March 26, 2019

Re: **Petition No. 1061:** Stamford Structure Replacement Project
Amendment to the Petition

STAMFORD STRUCTURE REPLACEMENT

Attachment A: Aerial Map

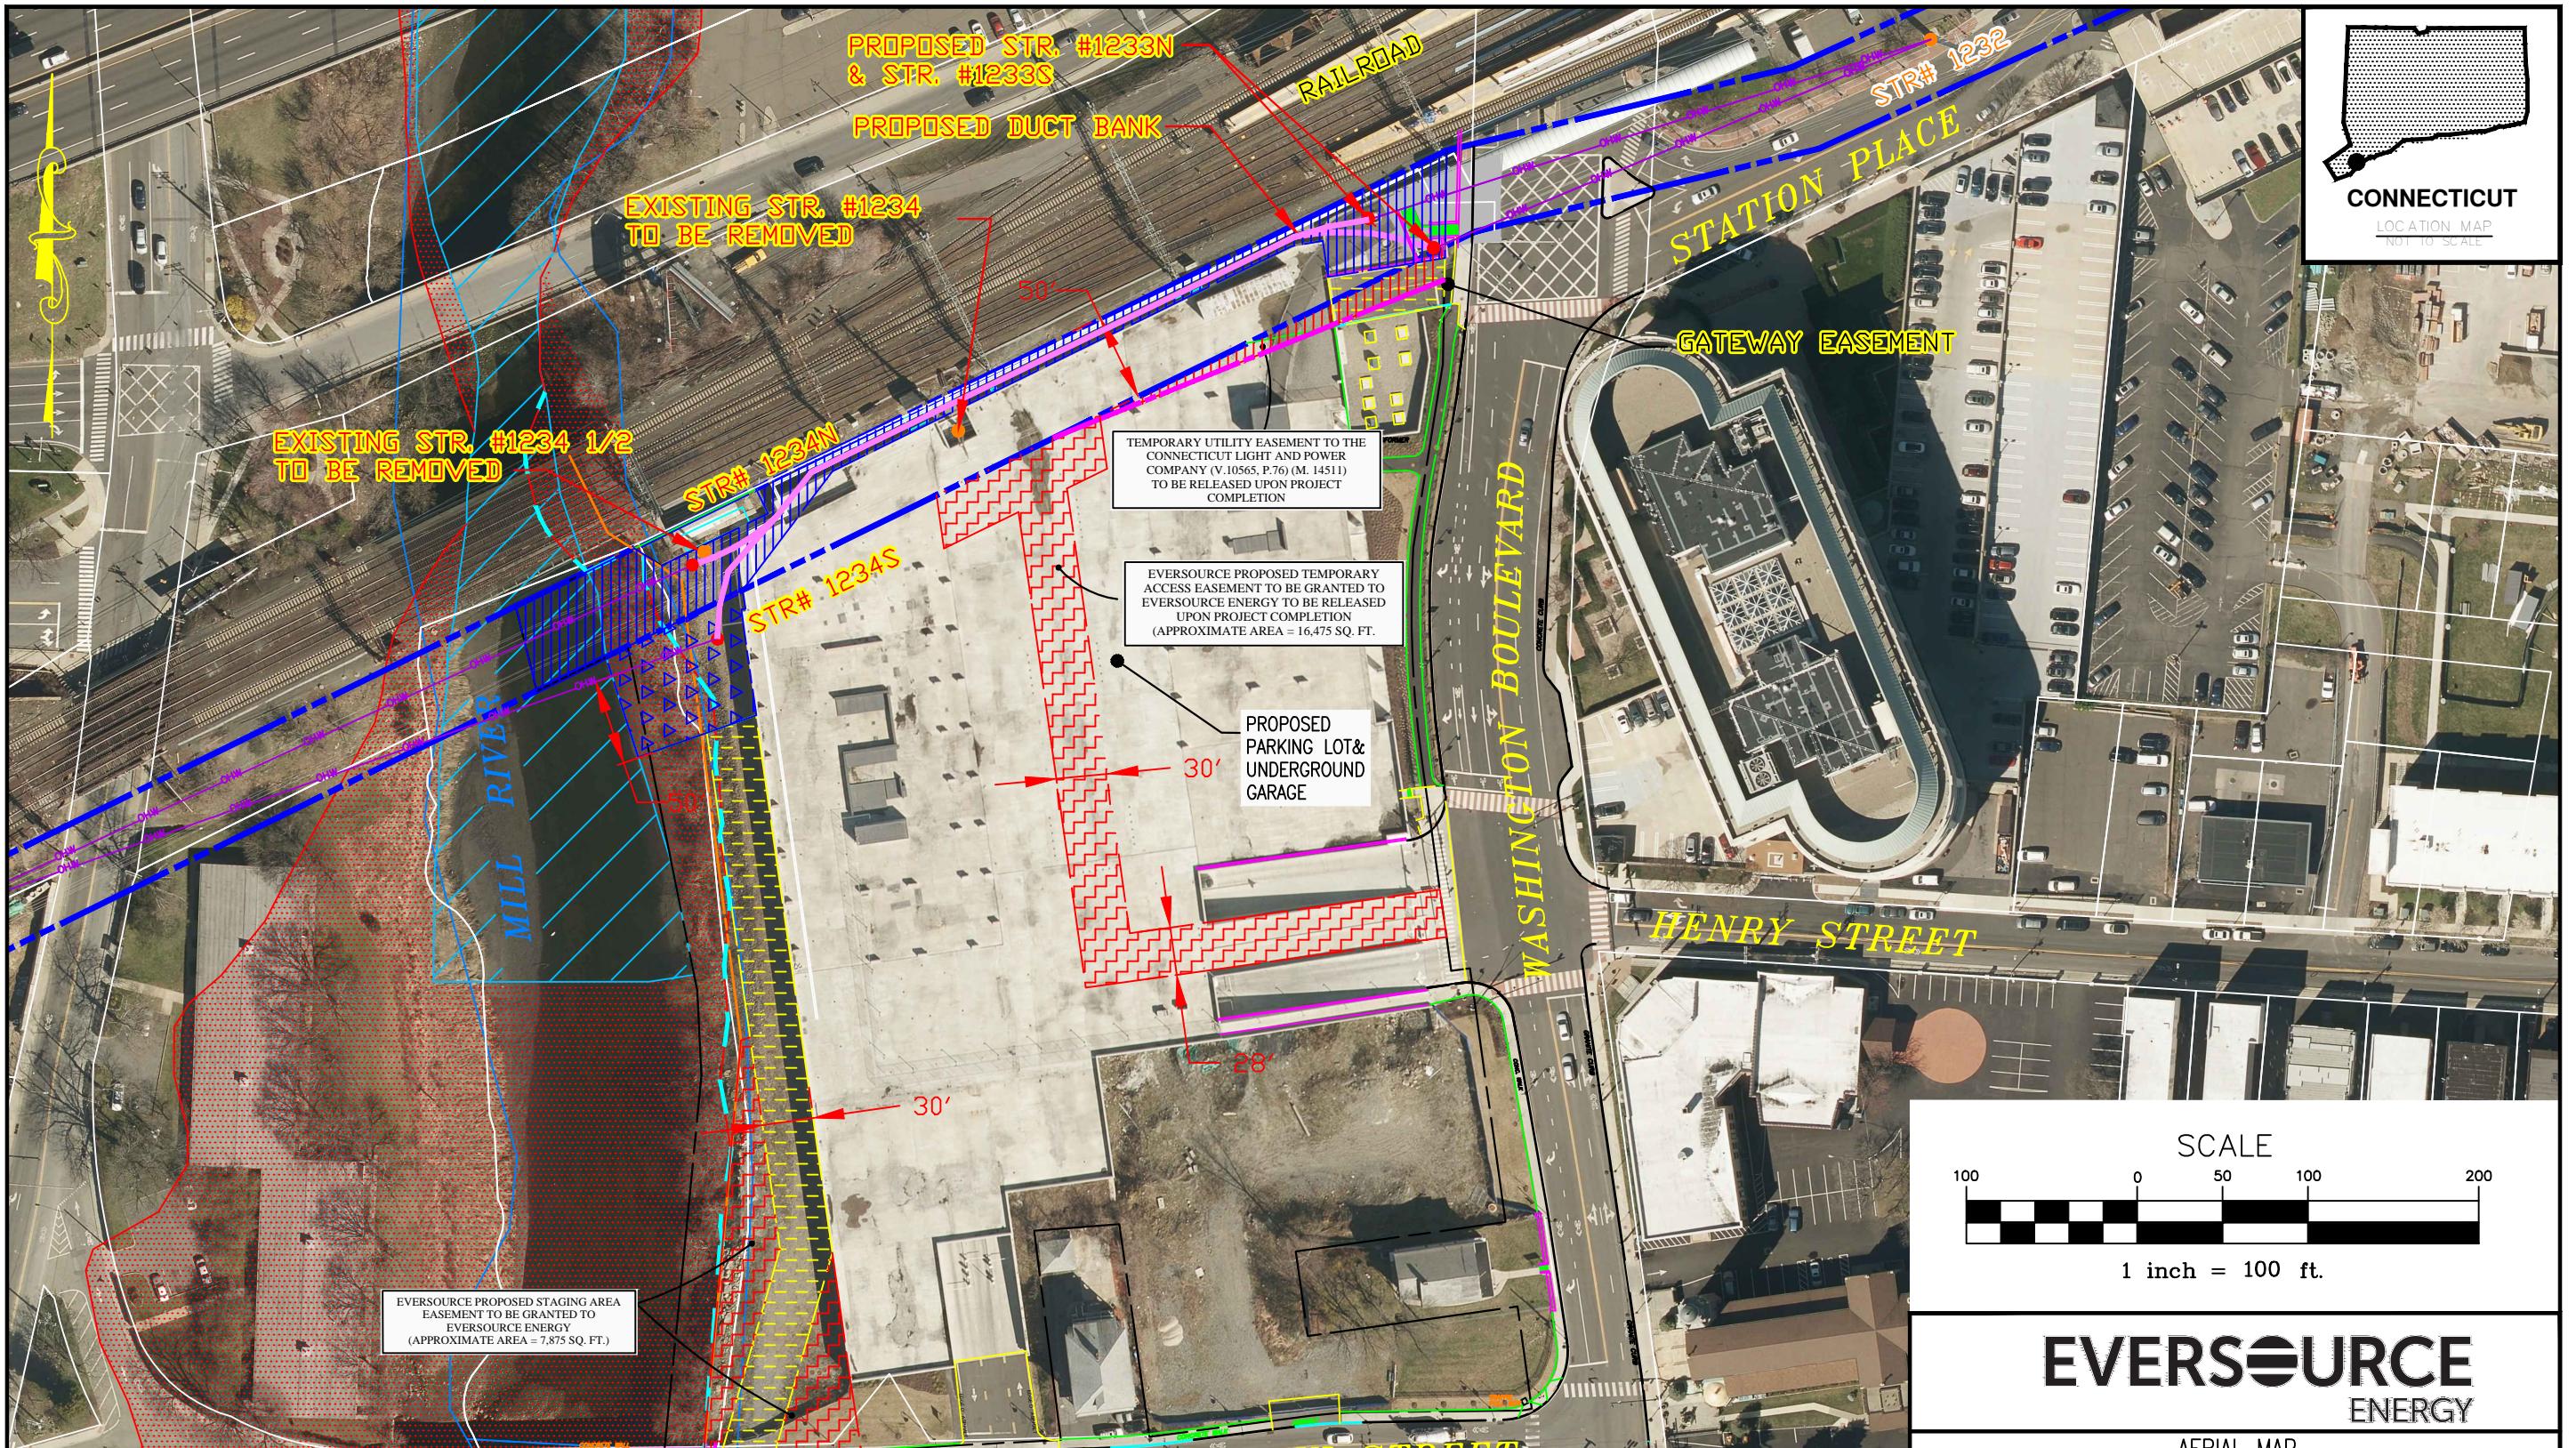
The 115-kV underground transmission line will consist of a double-circuit, solid dielectric cross-linked polyethylene ("XLPE") cable installed within polyvinyl chloride conduits, comprised of six 5000 kcmil copper cables (two circuits with three single 5000 kcmil cables each) installed within a concrete duct bank (see Attachment C for the typical XLPE cross section and Underground Duct Bank), that would extend approximately 500 feet between structures 1233 (N and S) and 1234 (N and S) within the Eversource ROW and HP Gateway property (see Attachment A: Aerial Map).

Attachment B: Drawing No. 01037-85003p001 - ROW Cross Section

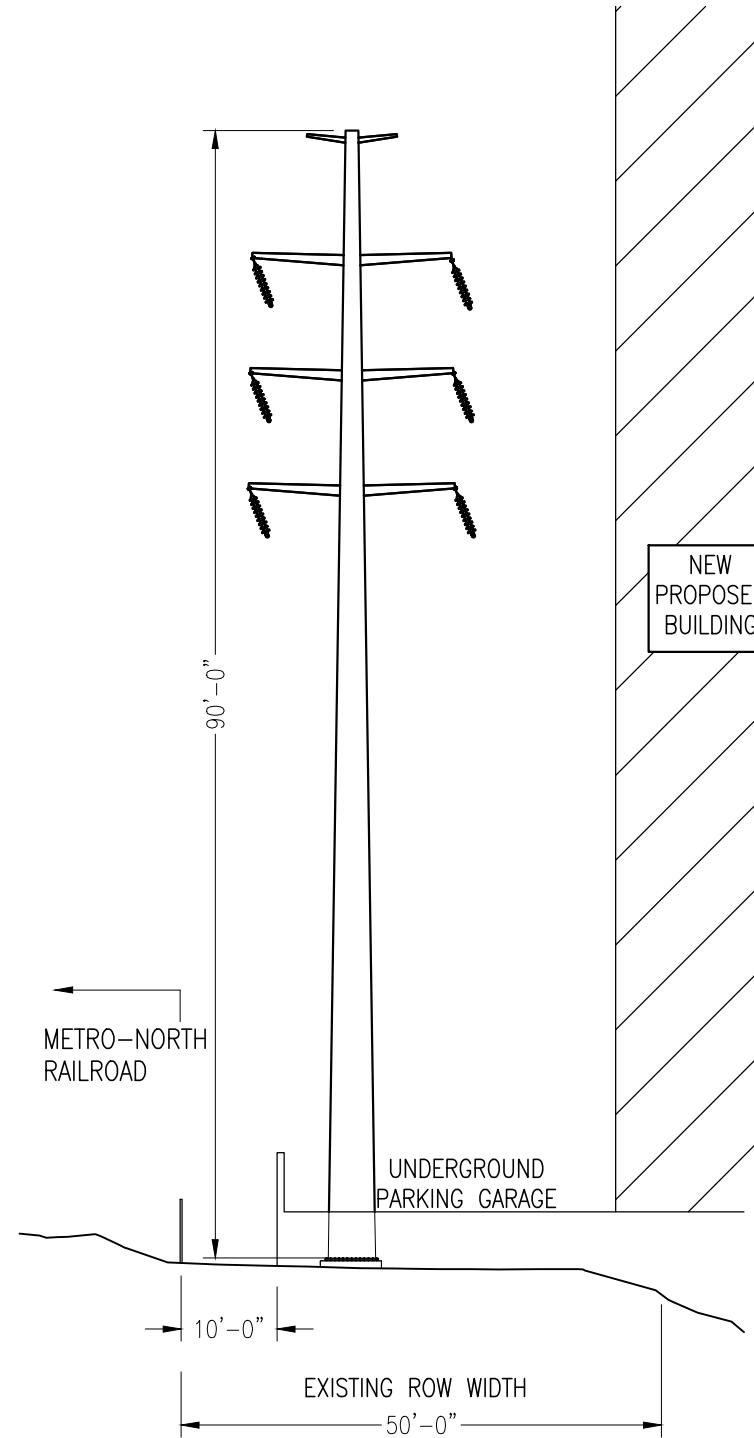
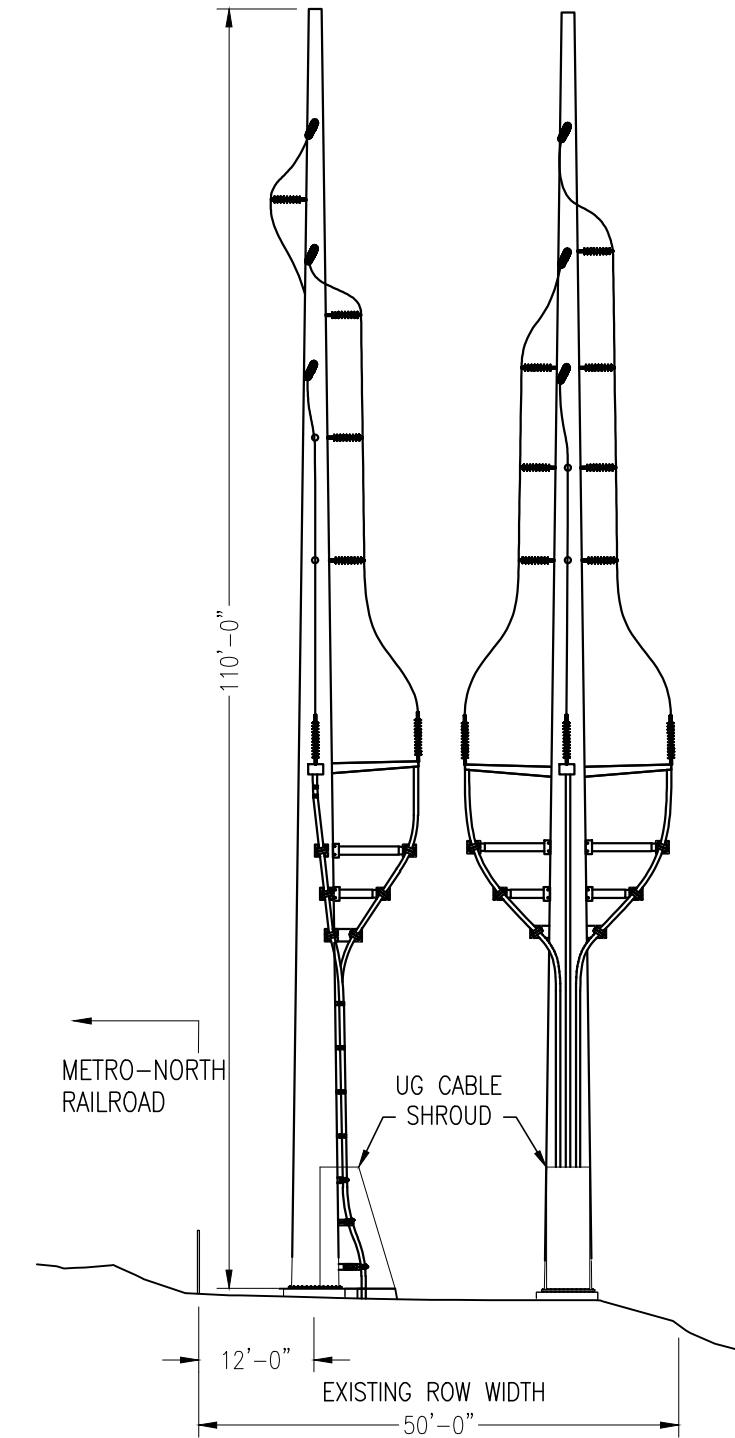
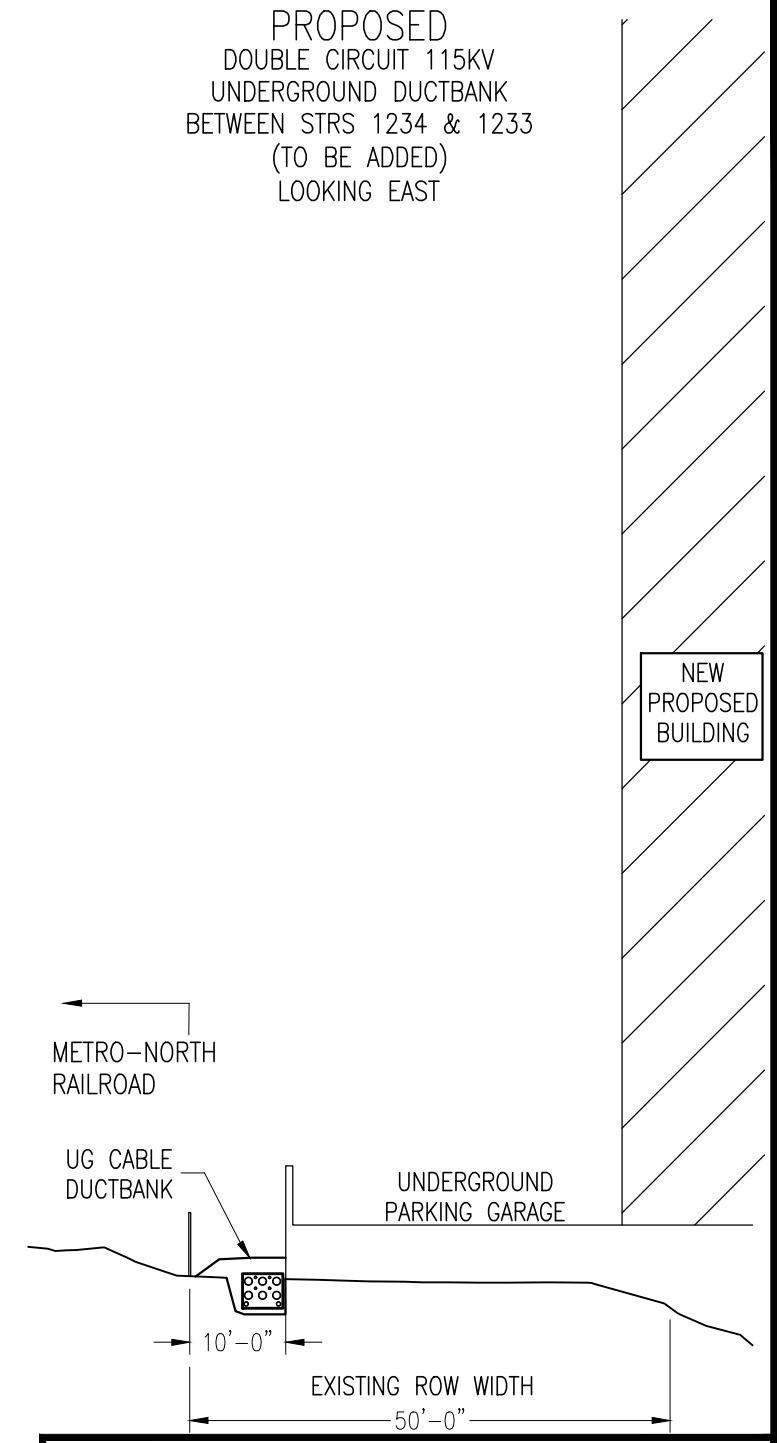
The proposed reconfiguration of Eversource's transmission facility modification ("Reconfiguration") would change the overhead configuration, incorporate an underground line segment configuration, replace two double-circuit 115-kV structures with four single-circuit 115-kV riser structures and change an existing

access road to the Eversource's ROW (See Attachment A: Aerial Map and Attachment B: Drawing No. 01037-85003p001 - ROW Cross Section). The Reconfiguration includes the following work components:

The concrete duct bank would have dimensions of approximately 3.5 feet wide by 3 feet deep and it would be buried approximately 3 feet below grade. Optimal cable phasing will be implemented to minimize magnetic field levels at ground level. The duct bank will also contain conduits for continuous ground cables, fiber optic communication and thermal monitoring cables. A portion of the duct bank will penetrate the existing northwest corner wall of the Developer's parking garage and pass through the parking garage before exiting and paralleling the north wall of the Developer's parking garage (see Attachment B: ROW Cross-Section).

- a) Replacement of the existing 115-kV double-circuit steel structure (No. 1234) with two 115-kV single-circuit galvanized steel riser structures (Nos. 1233N and 1233S)¹.
- b) Replacement of the 115-kV double-circuit steel structure (No. 1234.5) with two 115-kV single-circuit galvanized steel riser structures (Nos. 1234N and 1234S).

The height of the proposed riser structures would be 110 feet above ground. The height of the existing double-circuit structures is approximately 90 feet above ground. The proposed riser structures will be installed on concrete foundations².
